APPEAL SUMMARY

Appeal ID: 24637	Project Address: 4226 NE 161st Ave
Hearing Date: 2/24/21	Appellant Name: Daniel Bramske
Case No.: B-003	Appellant Phone: 651-734-8281
Appeal Type: Building	Plans Examiner/Inspector: Roza Malekzadeh
Project Type: commercial	Stories: 2 Occupancy: S-1, B Construction Type: V-B
Building/Business Name: Elite Electrical	Fire Sprinklers: Yes - fully sprinklered
Appeal Involves: Alteration of an existing structure, occ Change from S-1 to B	LUR or Permit Application No.: 20-225881-CO
Plan Submitted Option: pdf [File 1]	Proposed use: Electrical contractor offices and warehouse

ELITE ELECTRICAL GROUP OFFICE T.I.
4226 NE 161ST AVE SUITE B, PORTLAND, OR 97230

LIFE SAFETY

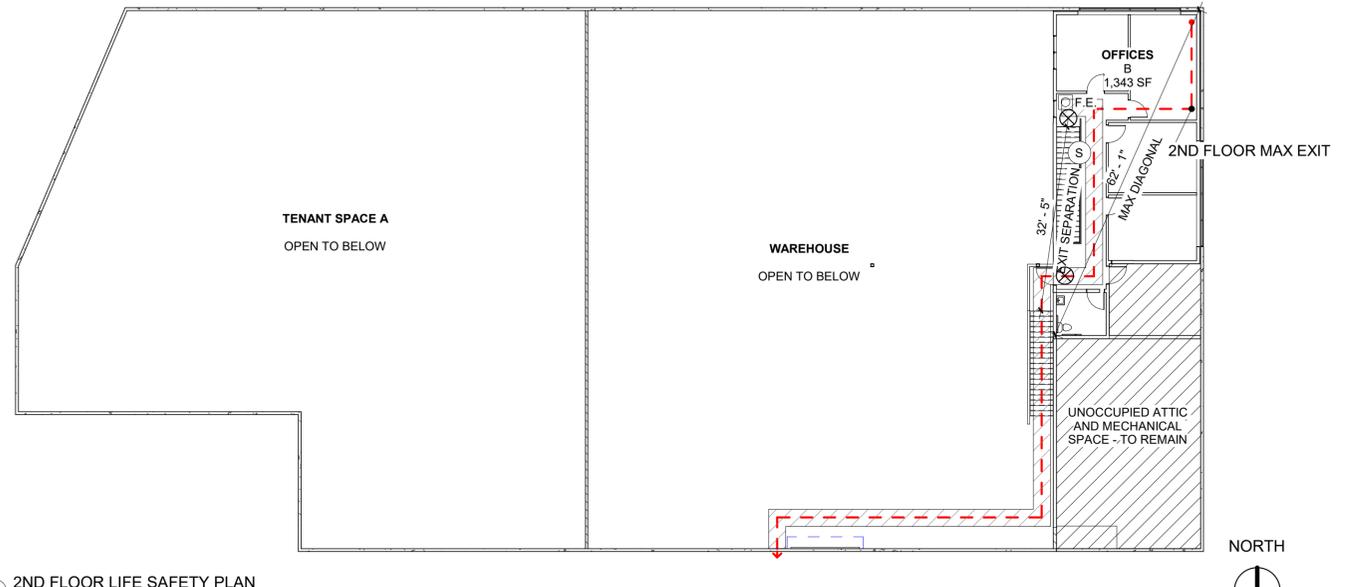
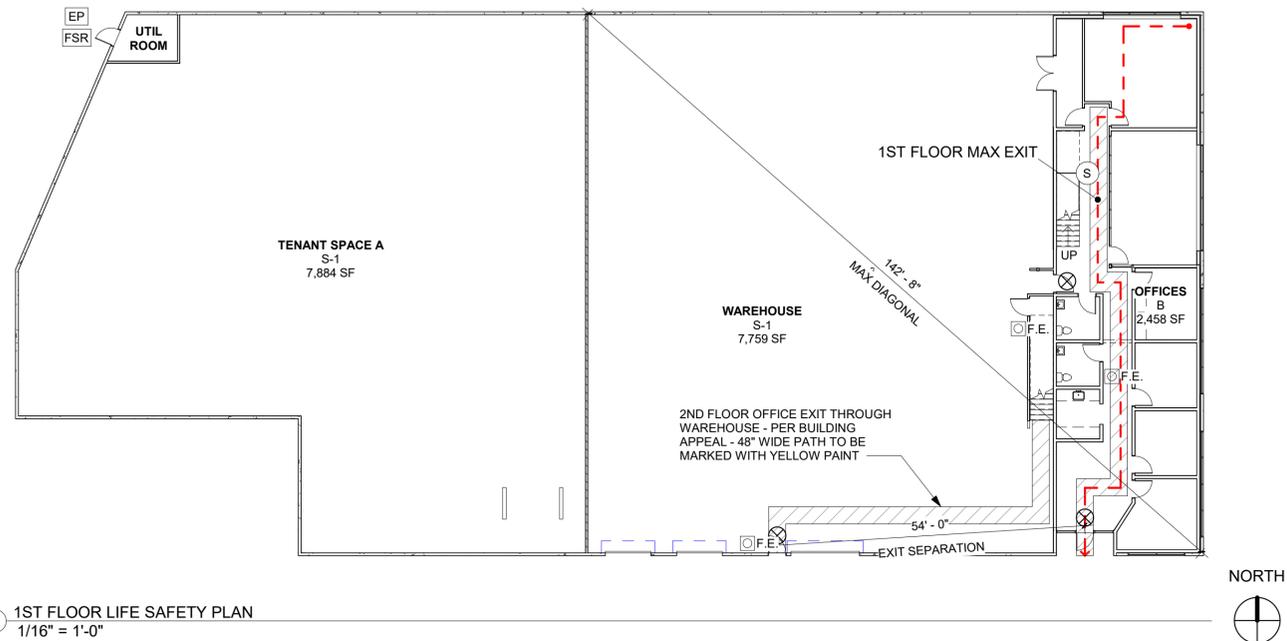
Code Section	OSSC 1016.2 Egress Through Intervening Spaces
Requires	Egress through intervening spaces shall comply with this section... Sec. 5 Egress shall not pass through kitchens, storage rooms, closets, or spaces used for similar purposes.
Code Modification or Alternate Requested	The intent of this appeal is to seek approval to allow one of the two stairs from the new second floor office to exit through the existing warehouse to the existing egress door.
Proposed Design	The building contains two floors of office space, adjacent to a two-story warehouse. One of two exit stairs from the second floor of the offices will exit onto the warehouse floor, approximately 52 feet from the existing exit door in the warehouse. The floor area along the egress path at the warehouse will be marked with a minimum 4'-0" wide area, in yellow paint, with "EXIT PATH". The proposed occupant load upstairs is only 9 occupants, and with the combination of a fully sprinklered building, two exits from the second floor, and a clearly marked egress path at the warehouse, we believe this to be an acceptable design that protects life safety.

Reason for alternative	Due the configuration of existing bathrooms, utilities, and finished spaces while still allowing the required separation of the staircases from the second floor, there is no reasonable alternative location for placing the proposed exit stairs. Additionally, creating an enclosed hallway would limit the effective use of the existing warehouse and loading dock.

Egress through intervening space: Granted provided the 2nd level is limited to employees only.
Appellant may contact John Butler (503 865-6427) or e-mail at John.Butler@portlandoregon.gov with questions.
